June 16, 2024

Attn: Squamish Council,

The Hazard and Risk Scenario

Figure 1. Location of Floatel 200 m NE of Woodfibre Creek mouth.

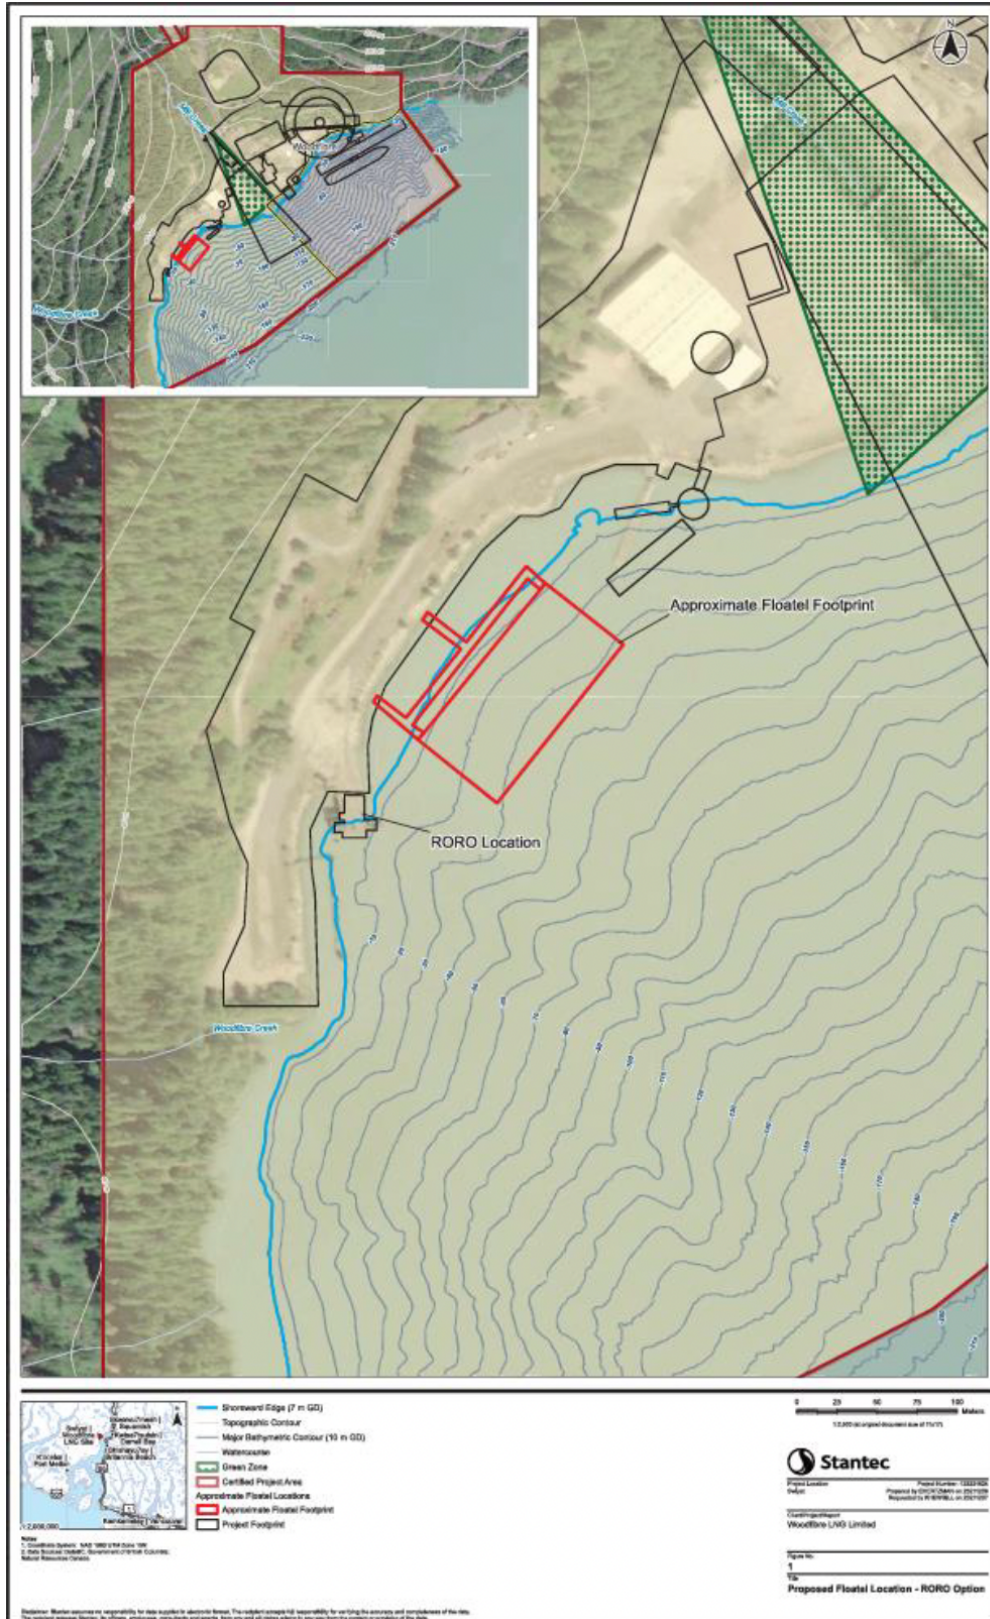
I attended the April 30, 2024 Floatel TUP Town Hall. There I heard concern expressed by the public regarding Henriette Lake dam safety and the Floatel float camp (Figure 1). I understand there is a deadline June 18, 2024 on the Floatel TUP application. As a Qualified Practitioner in the terrain sciences, required by the Professional Governance Act to speak out on matters of public safety, I offer my view of the expected scope for a risk assessment affecting the Floatel moored 200 m NE of Woodfibre Creek mouth and having a proposed carrying capacity of 650 persons.

The potential impact to the Floatel would depend on its anchoring location, mooring strategy, and proposed use of Woodfibre Creek as domestic water source. All or some of the following impacts are possible scenarios: direct impact to domestic water infrastructure and the ship itself, severe rocking, damage to moorings and setting adrift. Risk to life is credible.
